Subject: Duke Energy Corporation  
Oconee Nuclear Station - Units 1, 2, and 3  
Docket Nos. 50-269, 50-270, and 50-287

Revisions to Topical Report DPC-NE-3003 In Support of  
Steam Generator Replacement  
Response to NRC Staff Request for Additional  
Information

Enclosed herein, please find the Duke Energy Corporation (Duke) response to the May 12, 2003 NRC staff's request for additional information concerning topical report DPC-NE-3003, Revision 1, "Mass and Energy Release and Containment Response Methodology."

### **Duke Power Response To Request For Additional Information**

**GOTHIC 7.0 - FATHOMS COMPARISON**  
**ROTSG LARGE BREAK LOCA**  
(14.1 ft<sup>2</sup> Break - SG Inlet - High Initial RCS Flow w/ 5° ΔTcold Loop Case 1)

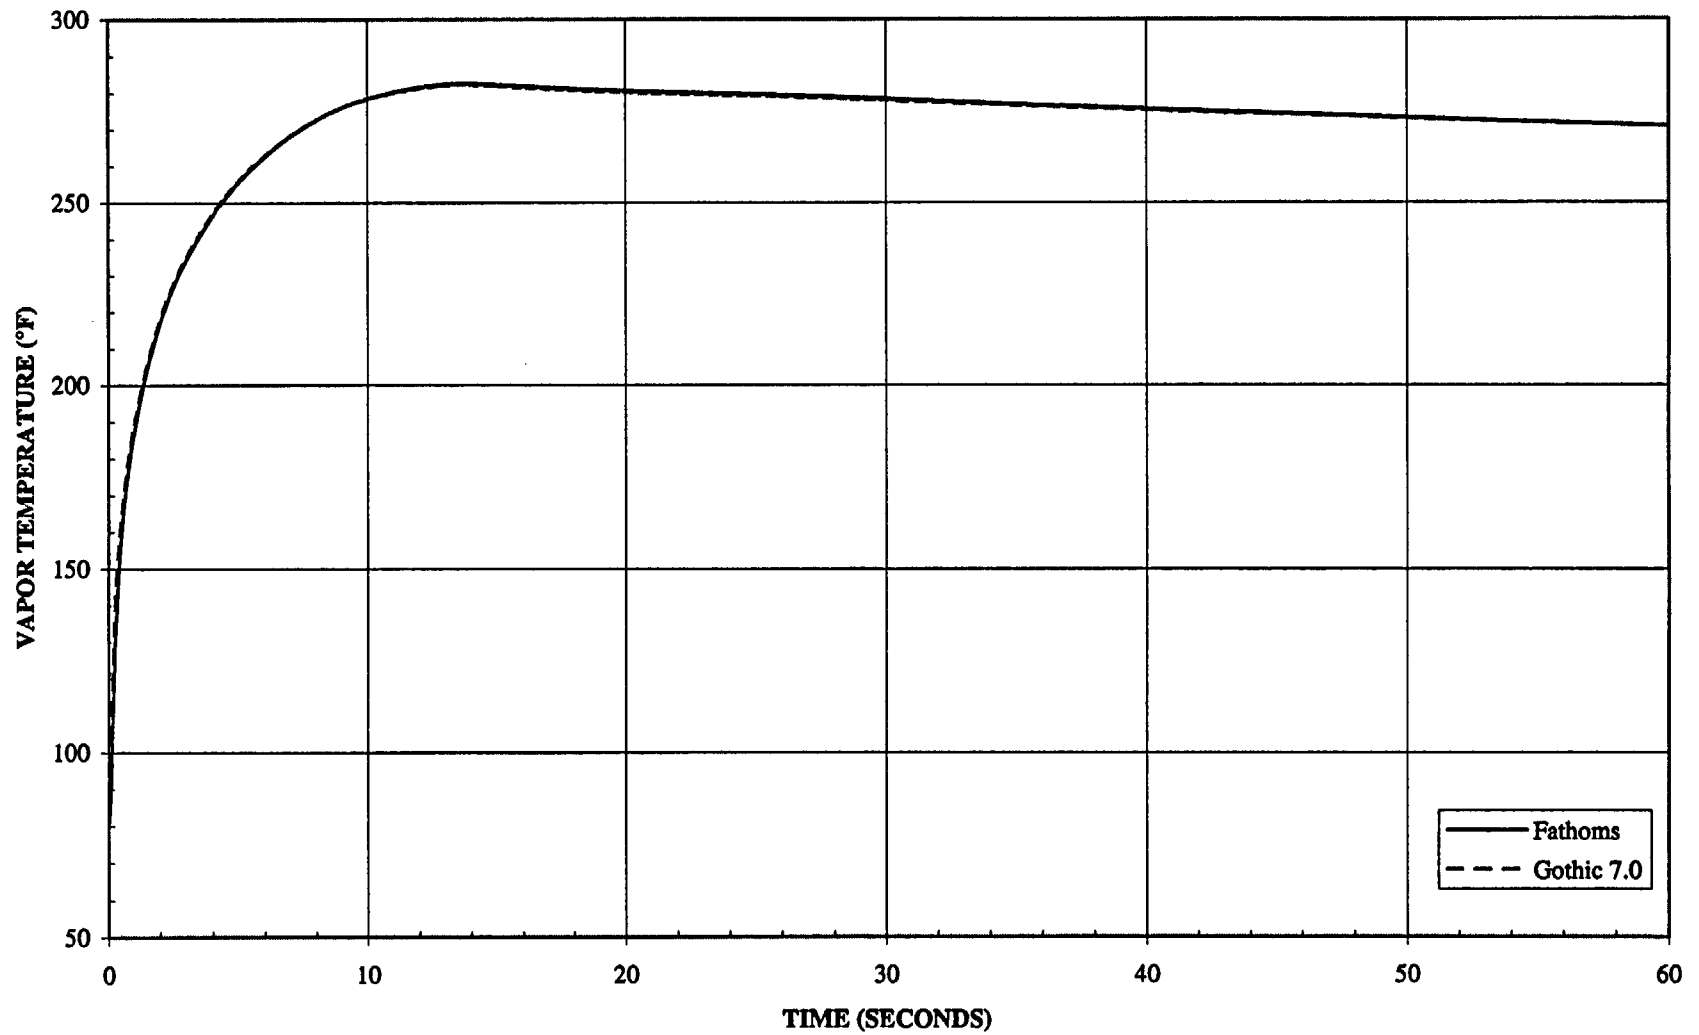
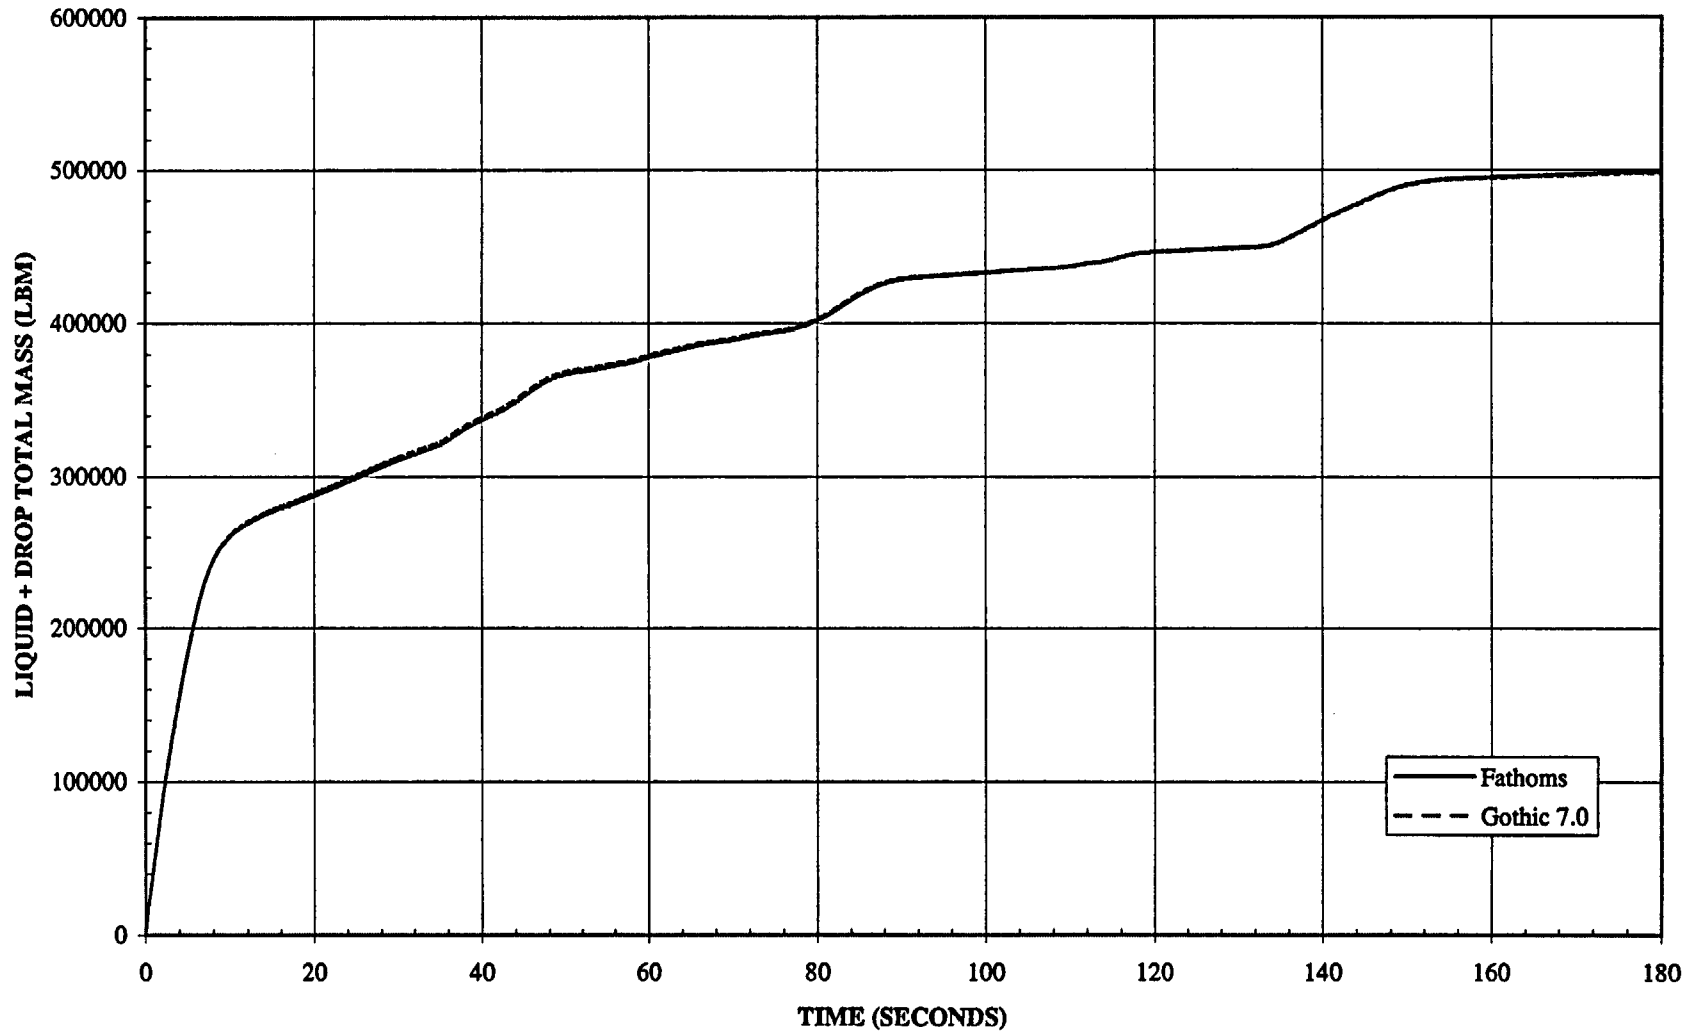
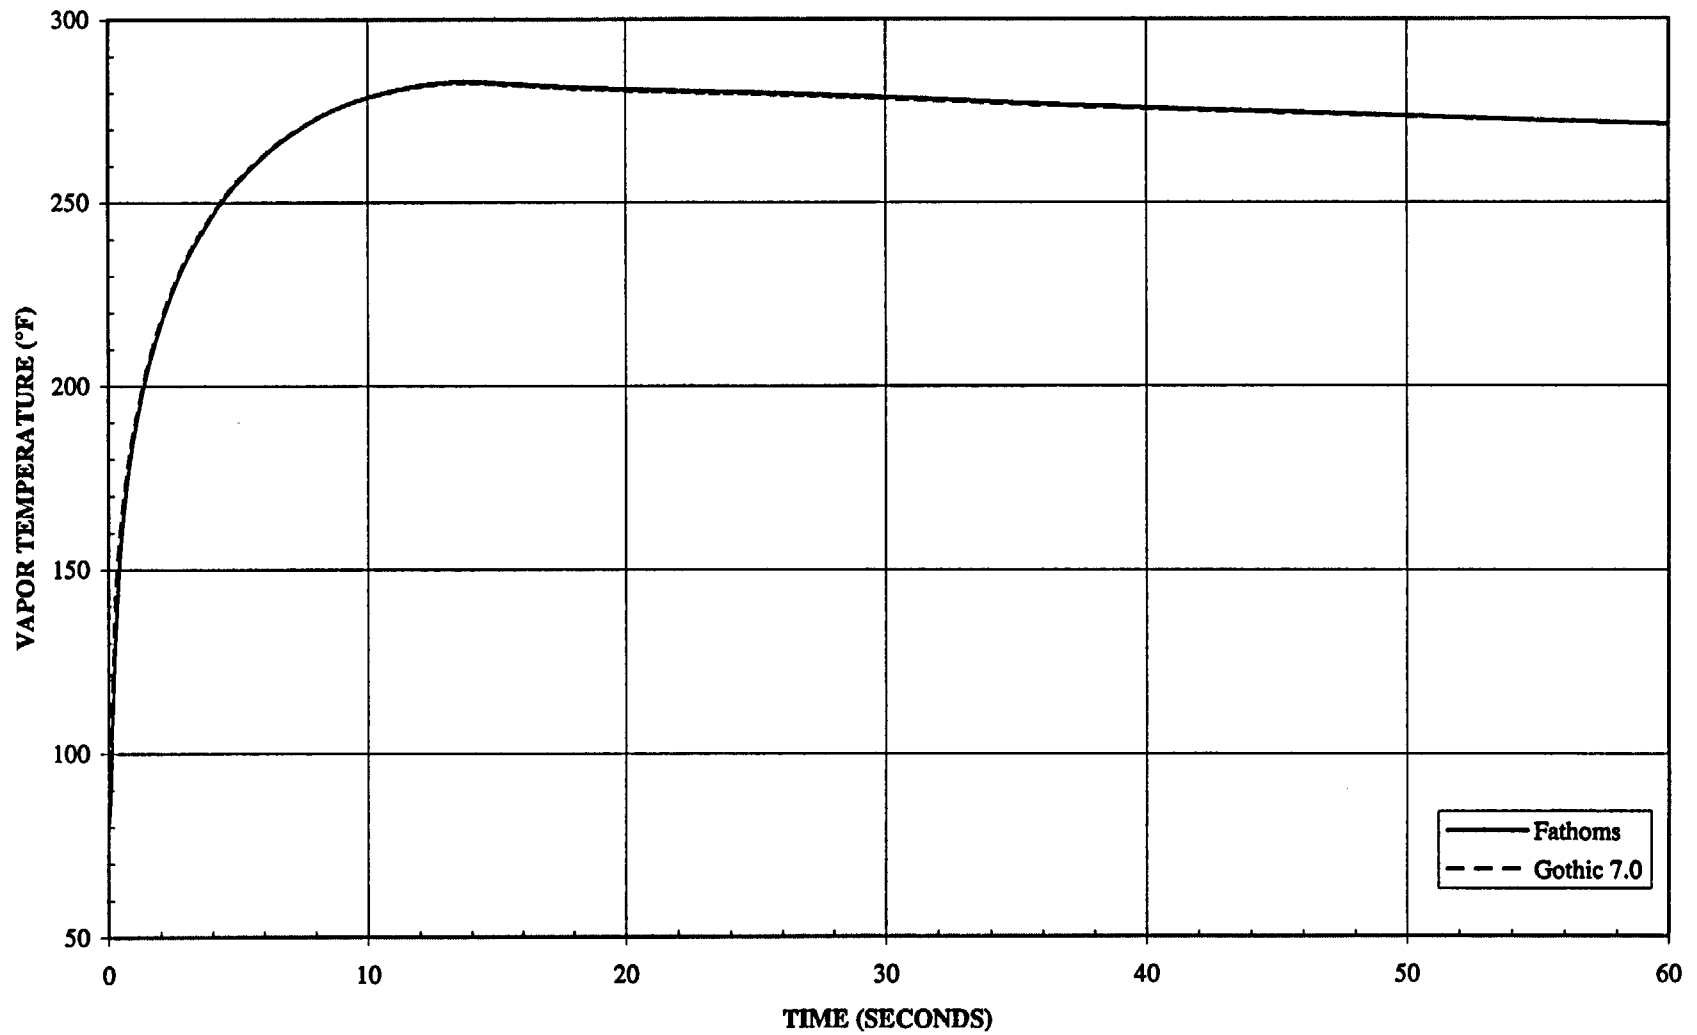
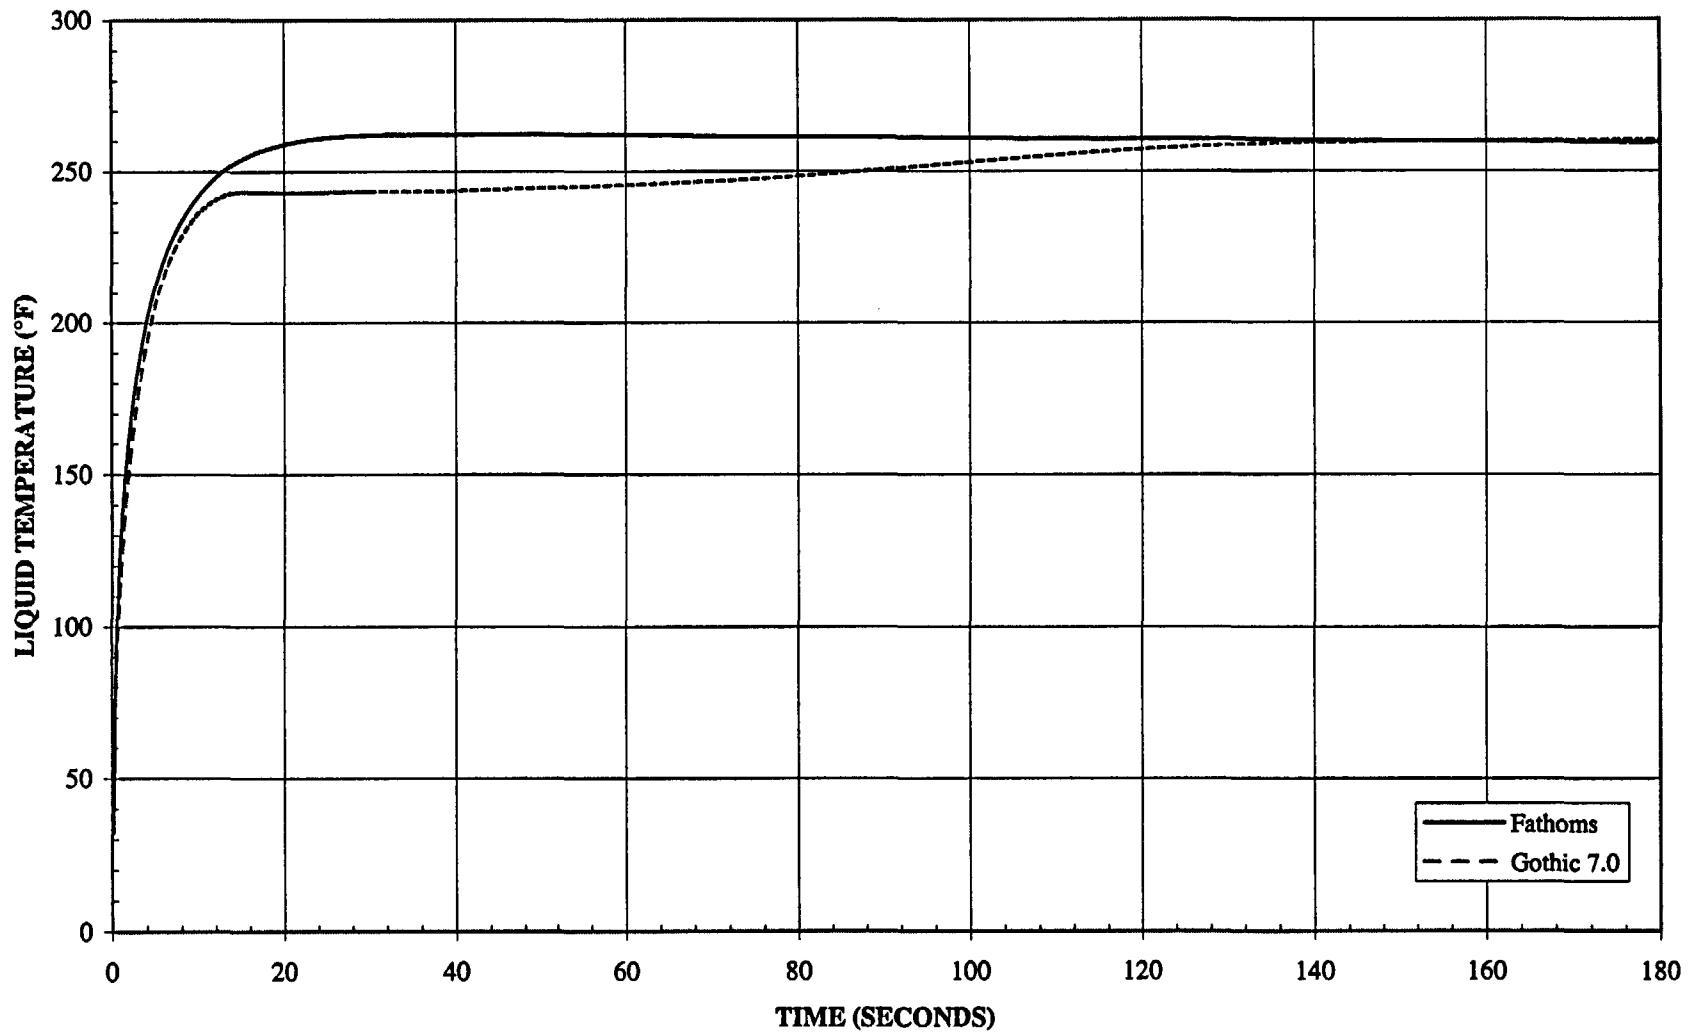
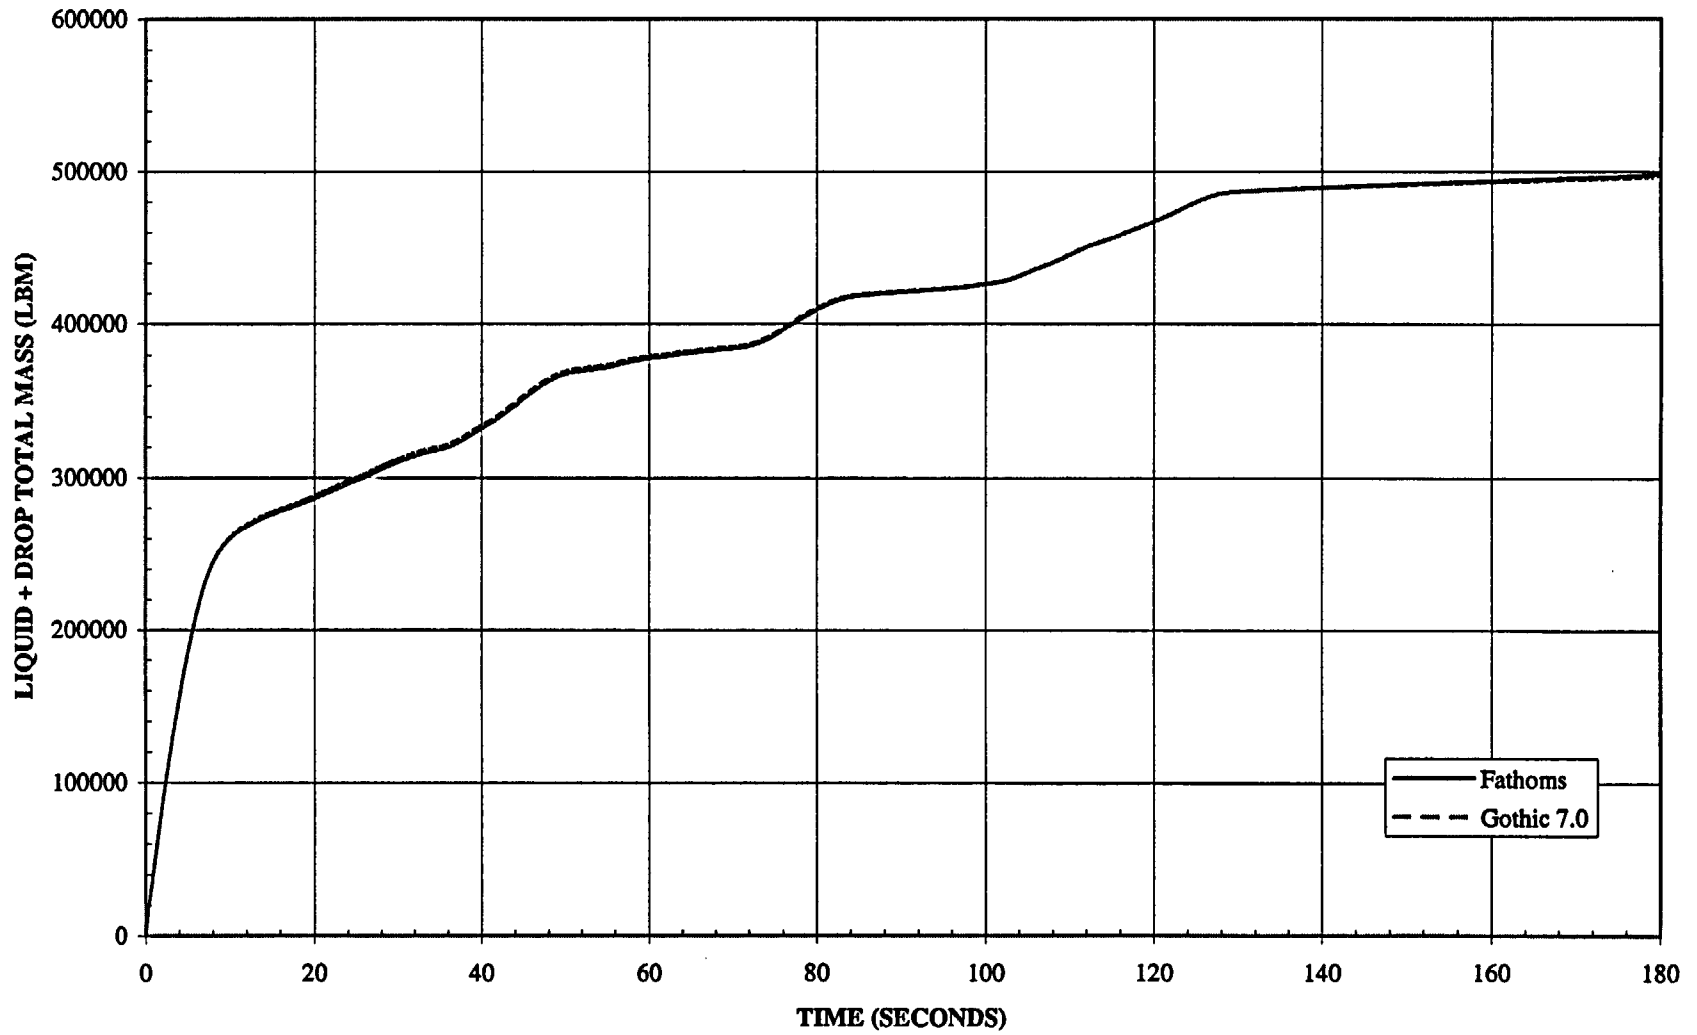
3. Please provide the results using the GOTHIC 7.0 code of peak pressure and temperature calculations for the sensitivity cases listed in Table 3.1-1 of DPC-NE-3003 in tabular and graphical form. If the results or conclusions are significantly different from those presented in DPC-NE-3003P, explain the difference.

Response: Table 3.1-1 of DPC-NE-3003 describes a spectrum of LOCA peak pressure cases including a range of break locations and sensitivity analyses for several important modeling assumptions. The staff's request is understood to focus on the difference in the predicted results from the FATHOMS and GOTHIC 7.0 code versions. Rather than show the comparison for the cases in Table 3.1-1, a different set of cases has been selected which is more focused on the current knowledge of the key sensitivity parameters. Also, the results presented are for the ROTSGs, which is the subject of Revision 1 to the topical report.

The results of the 14 code comparison analyses are shown in Table 3-1 below and in the figures that follow. In general, the pressure and vapor temperature response predictions were very similar in both magnitude and trend. GOTHIC 7.0 predictions for peak pressures and vapor temperature were slightly lower (~0.5 psig and 0.5°F). These differences are consistent with the code model differences described in the response to Question #1. Both codes predict a saturated containment atmosphere due to the large amount of drops injected. The slightly lower pressure, vapor temperature, and liquid temperature from GOTHIC 7.0 may be attributed to additional drop hold up in the atmosphere. This effectively increases the heat capacity of the atmosphere and reduces the temperature rise for a given energy addition. A comparison of the total liquid and drop masses, and liquid temperatures, show the predictions of the two codes to be essentially the same. This is consistent with the changes in the drop deposition and entrainment models discussed in Question #1. These results show that the two code versions give essentially similar results for the same break location and initial and boundary conditions.
